ADDENDUM No. 1 TO BID DOCUMENTS FOR THE

LITTLE LAKE SHORELINE PROTECTION AND MARSH CREATION
SEGMENT 1 AND 2 DEMOLITION & PERPENDICULAR ROCK DIKE
CONSTRUCTION PROJECT BA-0037

STATE OF LOUISIANA
COASTAL PROTECTION AND RESTORATION AUTHORITY

March 2nd, 2018

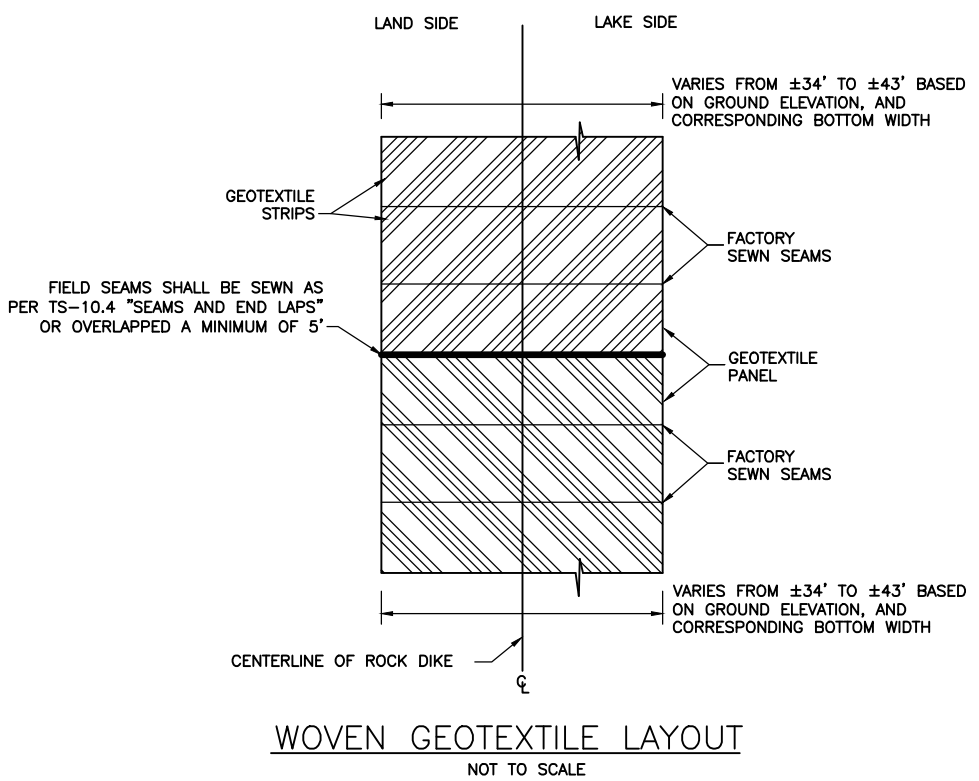
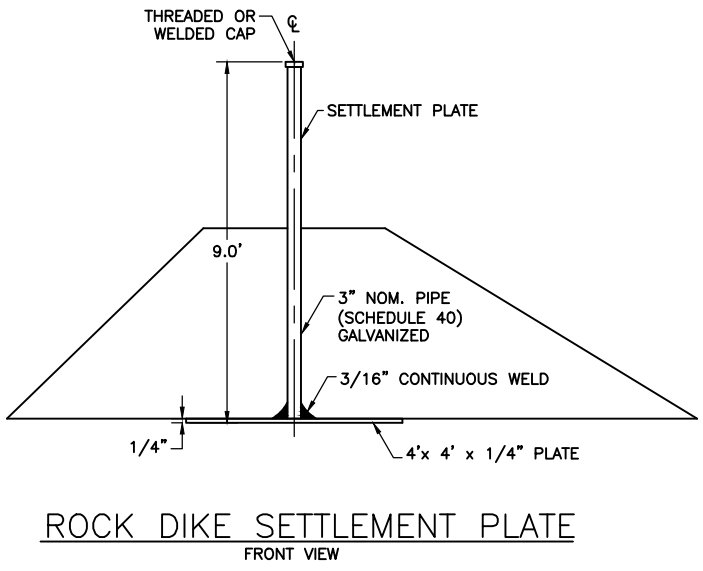
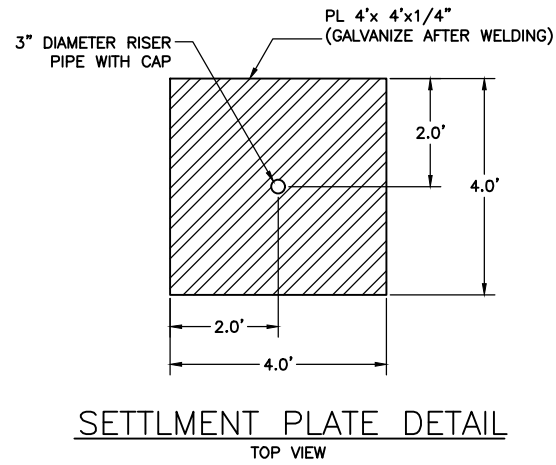
7. **Question:** Must “Temporary” Piles be 60’ in length, or can we use a shorter pile for the Temporary Signs?

Answer: The Contract documents have conflicting information regarding length of timber piling. All timber piling shall hereby be 50 feet in length. See Attachment D of this Addendum for plan sheets reflecting the change.

REV.	A	03/02/18	UPDATED TIMBER PILING TO BE 50 FEET IN LENGTH	B.J.H.	COASTAL PROTECTION AND RESTORATION AUTHORITY 150 TERRACE AVENUE BATON ROUGE, LOUISIANA 70801		BA-37 Segment 1 & 2 Demolition & Perpendicular Rock Dike Construction		WARNING SIGN AND SETTLEMENT PLATE DETAIL	
							STATE PROJECT NUMBER: BA-37			
							FEDERAL PROJECT NUMBER: BA-37		DATE: 01/2018	
							APPROVED BY: B.J.H.		SHEET 4A OF 14	
							DRAWN BY: B.J.H.		DESIGNED BY: B.J.H.

ADD: “For the timber mounted warning signs, each of the sign shall be fabricated from 3/4 inch thick sign grade plywood or approved equal, and bolted to one (1) 12" diameter (nominal end) x 50 ft long timber piling after it is driven to the proper depth, as shown on the Construction Drawing Typical Details.”.

- TIMBER PILING SHALL BE 50- FEET IN LENGTH WITH A NOMINAL 12-INCH DIAMETER BUTT AND 7-INCH MINIMUM DIAMETER AT THE TIP.
 - TEMPORARY WARNING SIGNS SHALL HAVE THE SAME COLORING AND REFLECTIVE TAPE AS PERMANENT SIGNS BUT MAY BE CONSTRUCTED WITH 3/4" SIGN GRADE PLYWOOD.

BA-37 Segment 1 & 2 Demolition & Perpendicular Rock Dike Construction		PLAN/PROFILE ROCK DIKE SEGMENT 1&2
STATE PROJECT NUMBER: BA-37		DATE: 01/2018
FEDERAL PROJECT NUMBER: BA-37		
APPROVED BY: B.J.H.		SHEET 5A OF 14

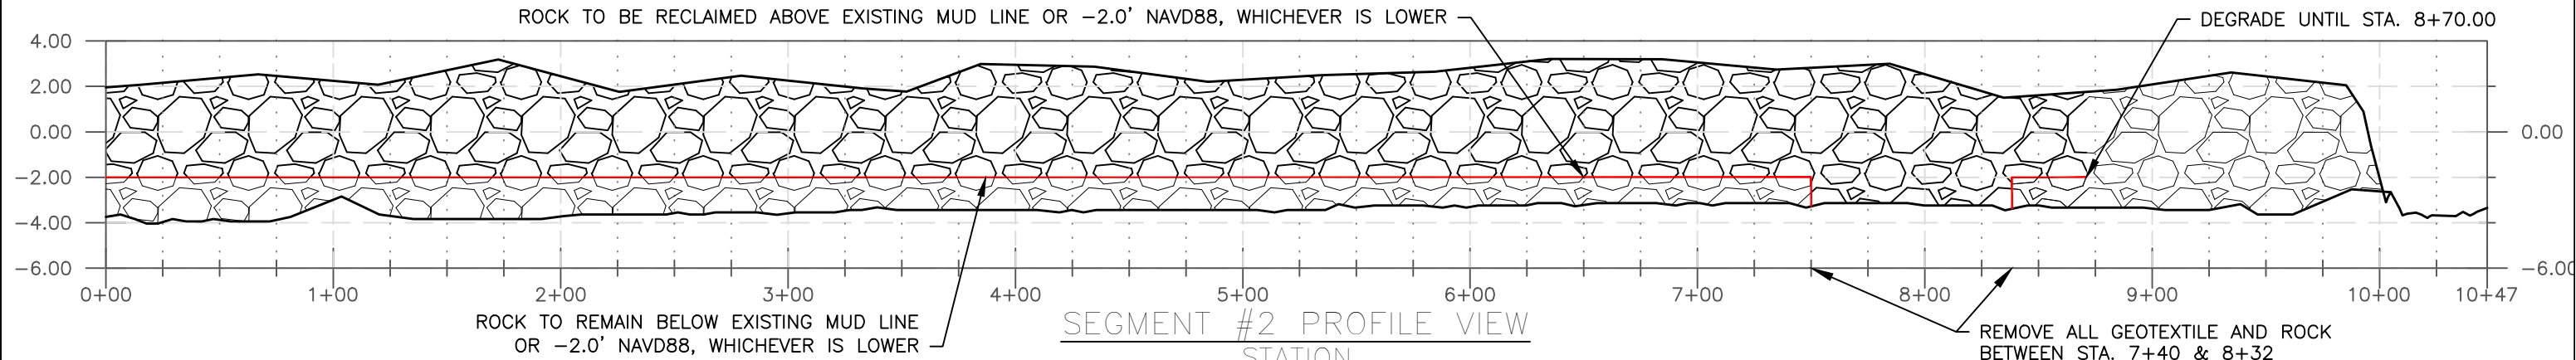
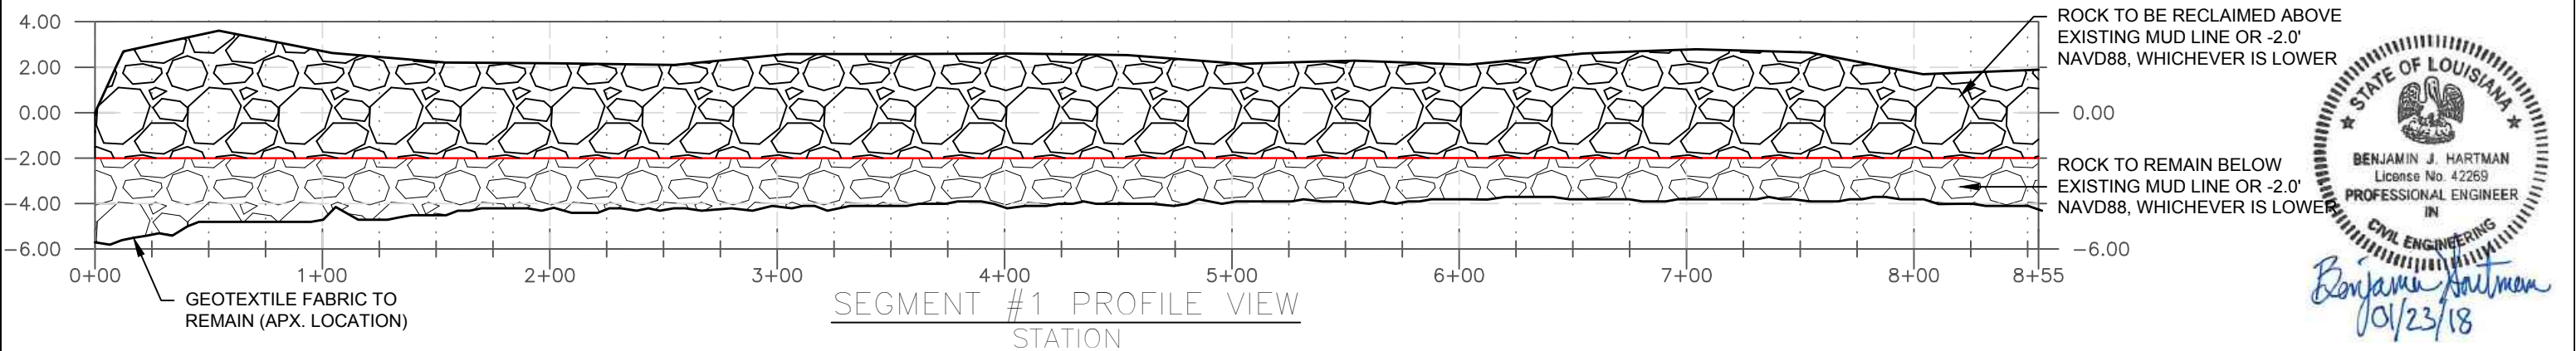
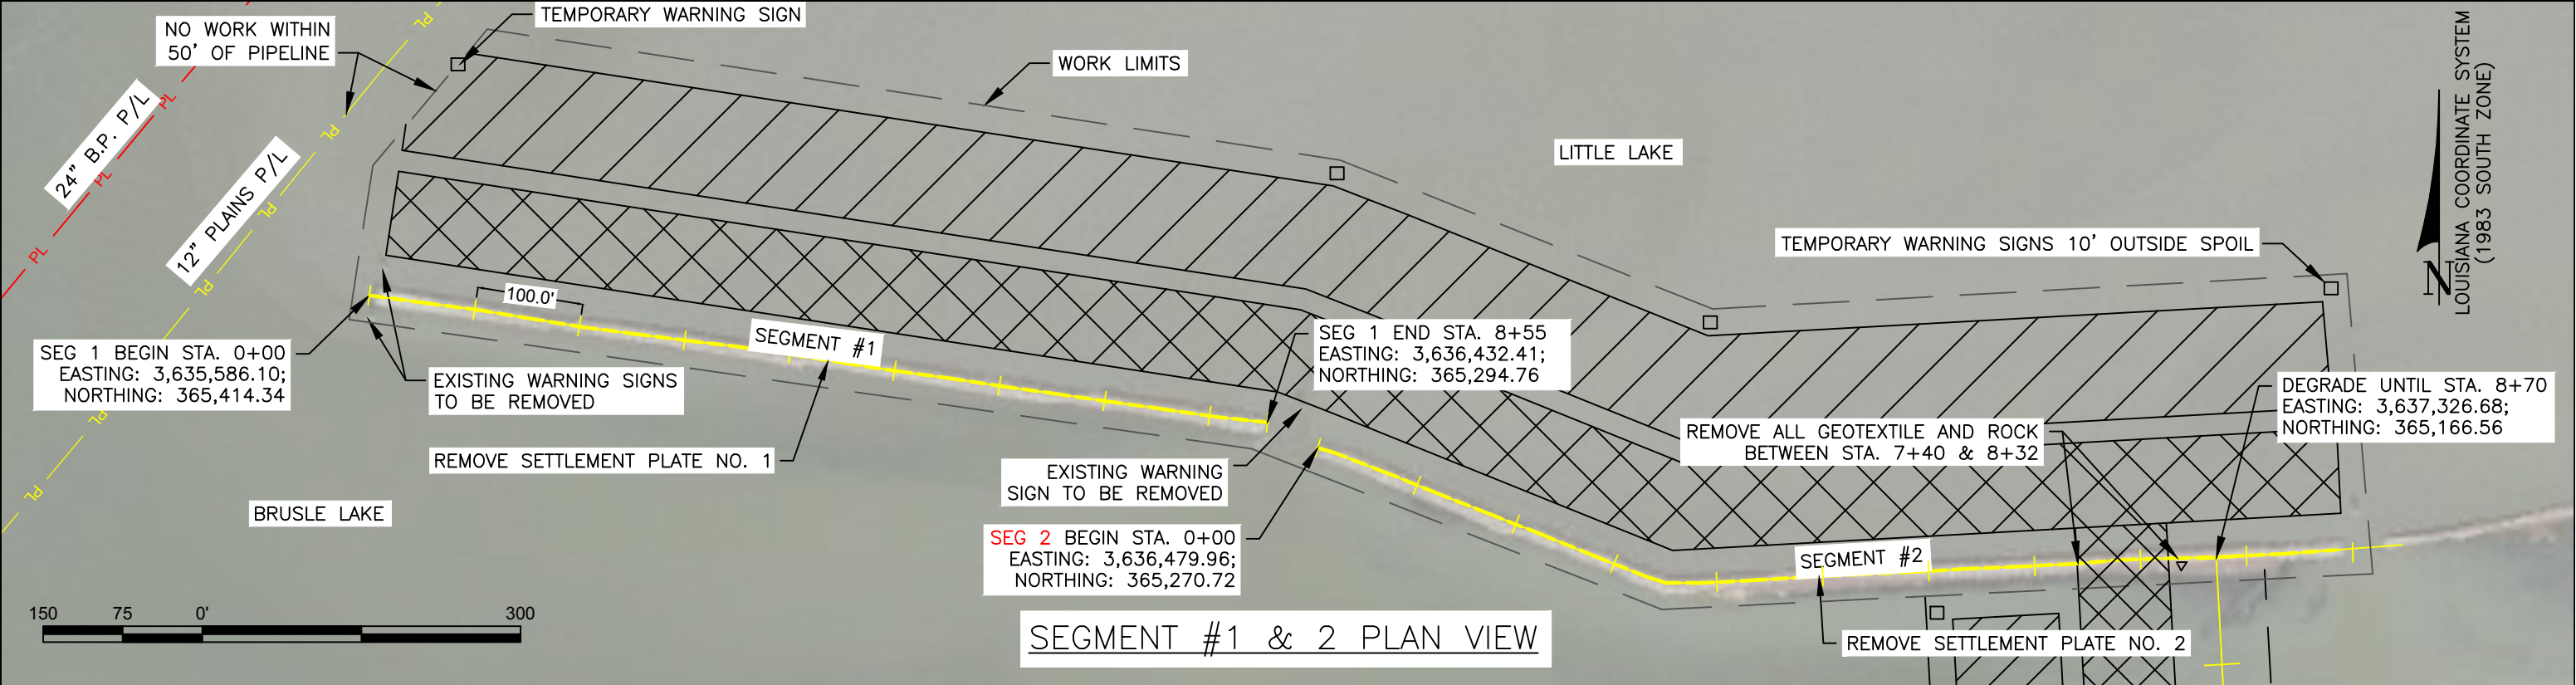
A	03/02/18	CORRECTED TEXT BOX ON PLAN VIEW TO SAY SEG NO. 2 INSTEAD OF SEG NO. 1	BJH
REV.	DATE	DESCRIPTION	BY

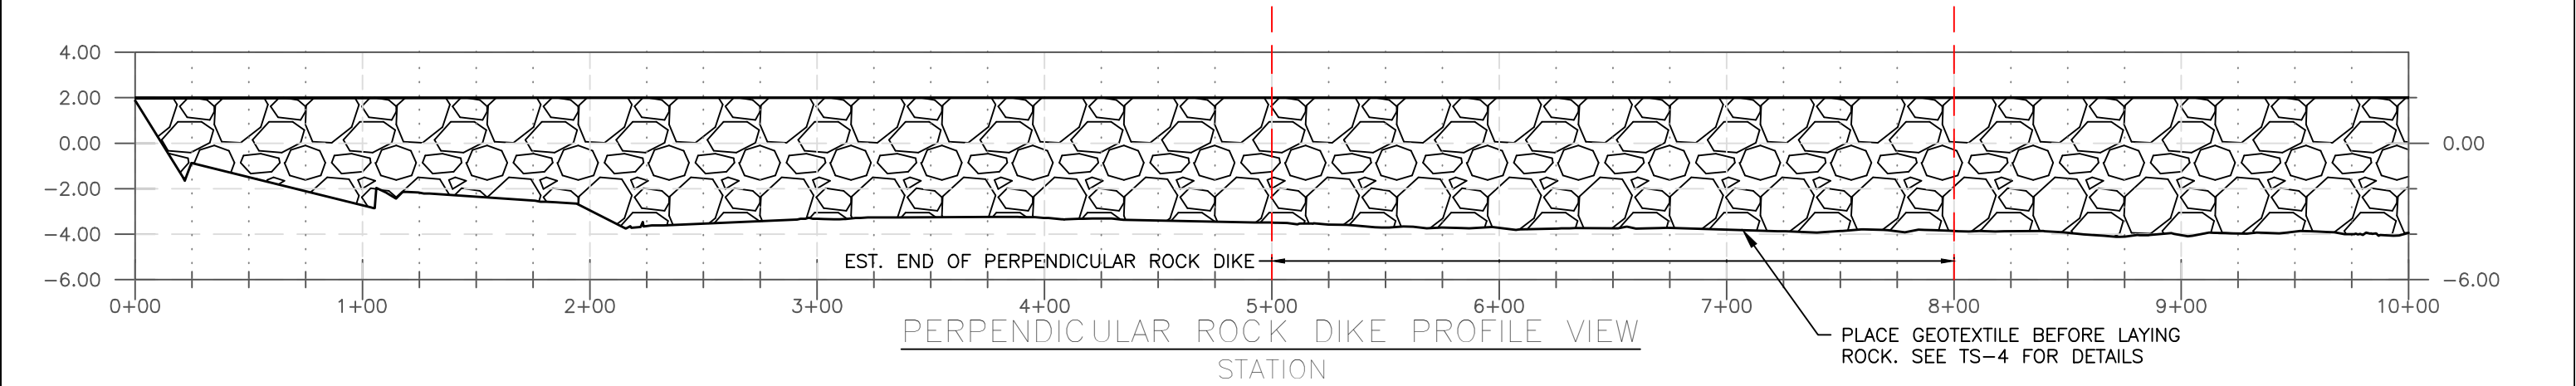
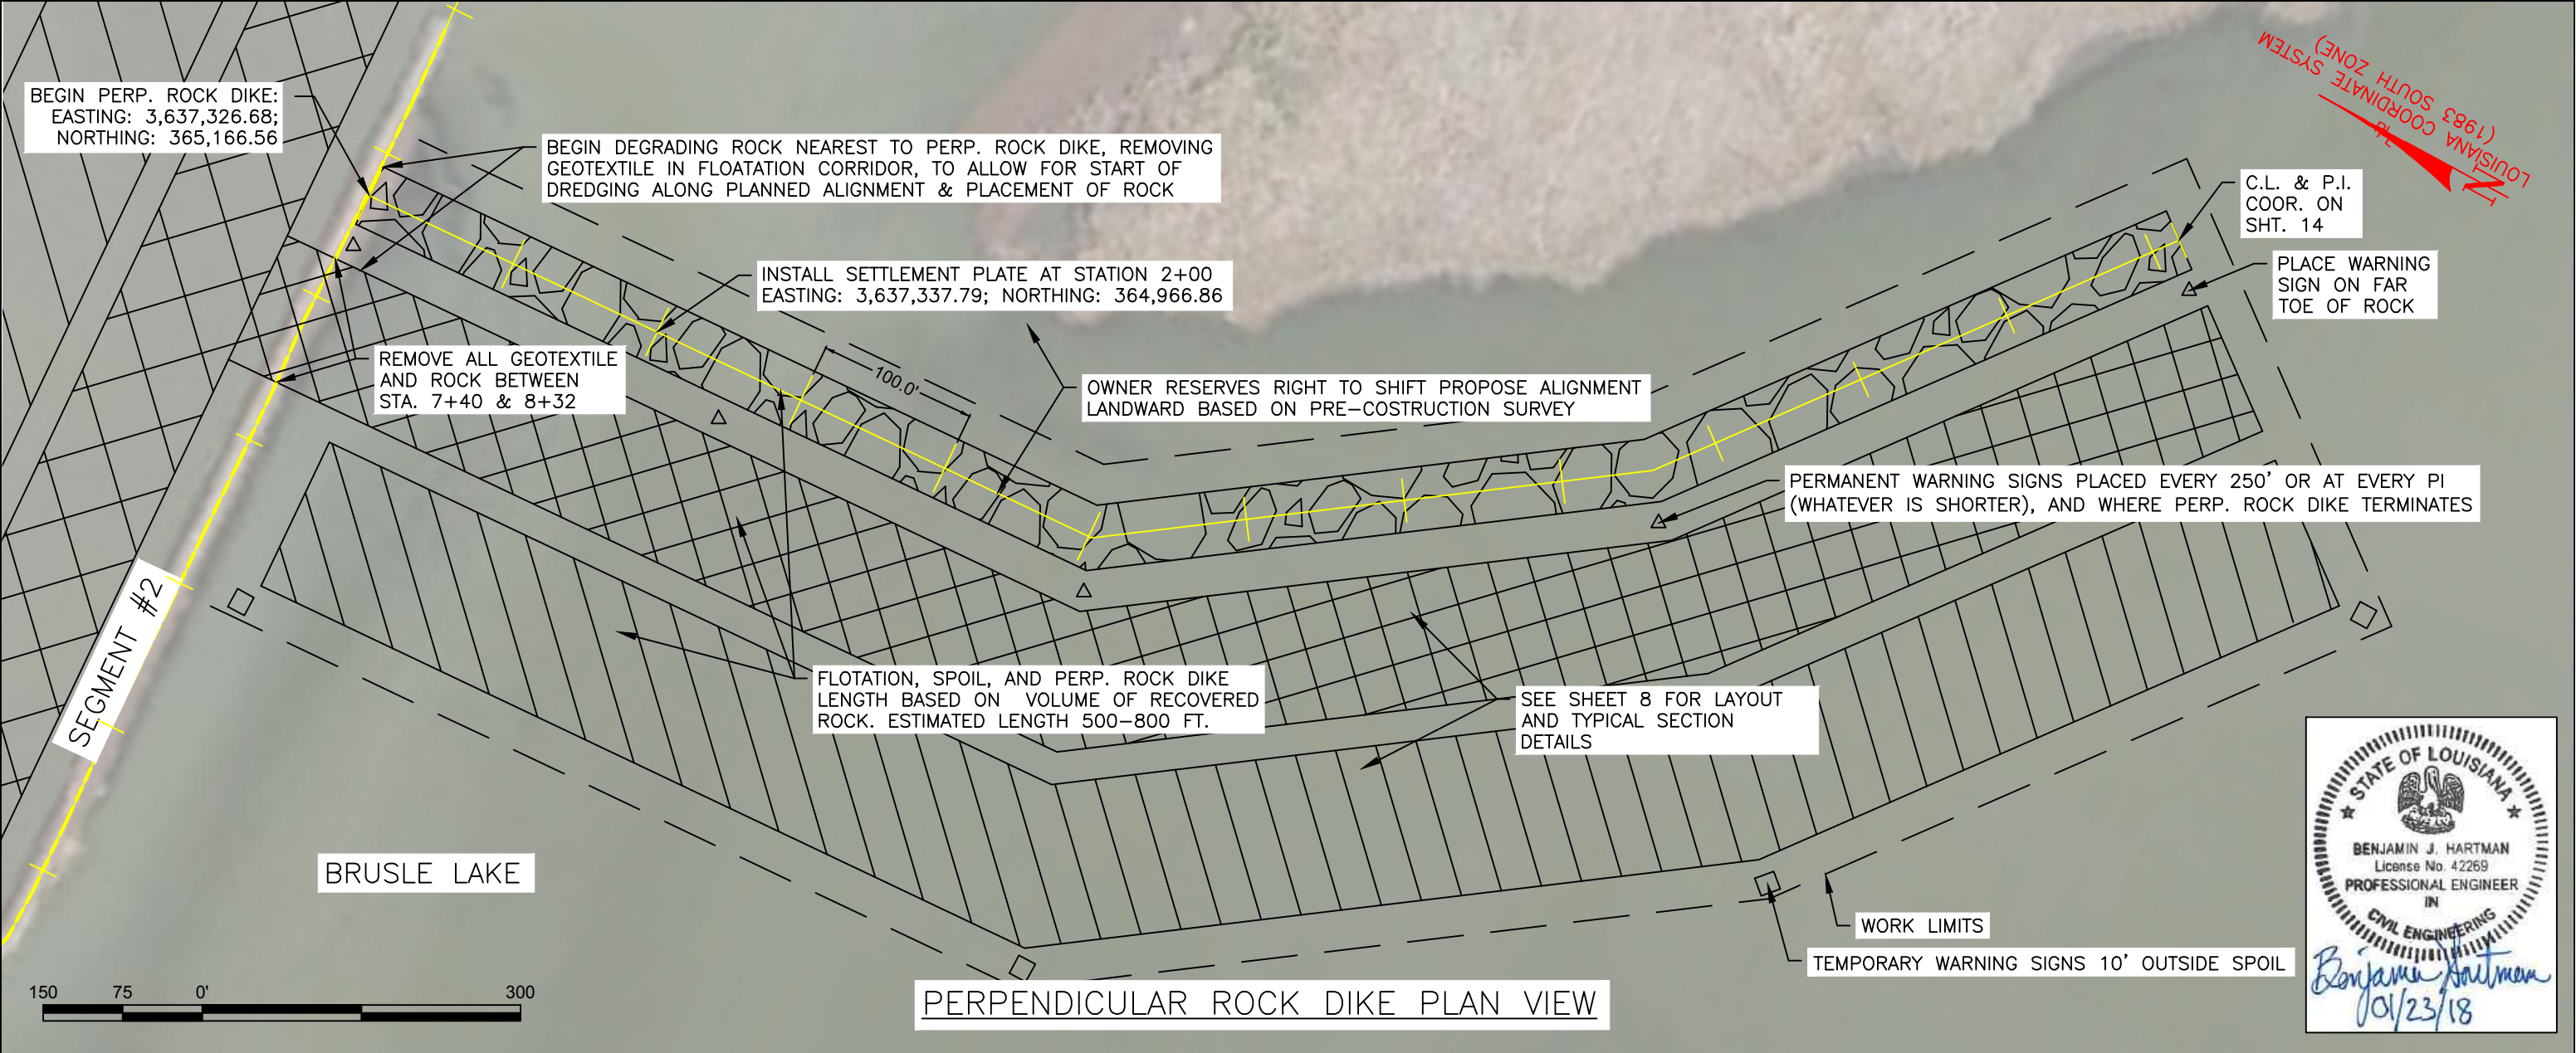
6. **Question:** Is the “North” arrow on Plan Page 6 of 14 correct?

Answer: The “North” arrow on the original plan set is incorrect and is shown revised in Attachment D of this Addendum.

A	03/02/18	CORRECTED ORIENTATION OF NORTH ARROW	BJH	COASTAL PROTECTION AND RESTORATION AUTHORITY 150 TERRACE AVENUE BATON ROUGE, LOUISIANA 70801	BA-37 Segment 1 & 2 Demolition & Perpendicular Rock Dike Construction		PLAN/PROFILE PERP. ROCK DIKE
					STATE PROJECT NUMBER: BA-37		
					FEDERAL PROJECT NUMBER: BA-37		DATE: 01/2018
REV.	DATE	DESCRIPTION	BY	DRAWN BY: B.J.H.	DESIGNED BY: B.J.H.	APPROVED BY: B.J.H.	SHEET 6A OF 14
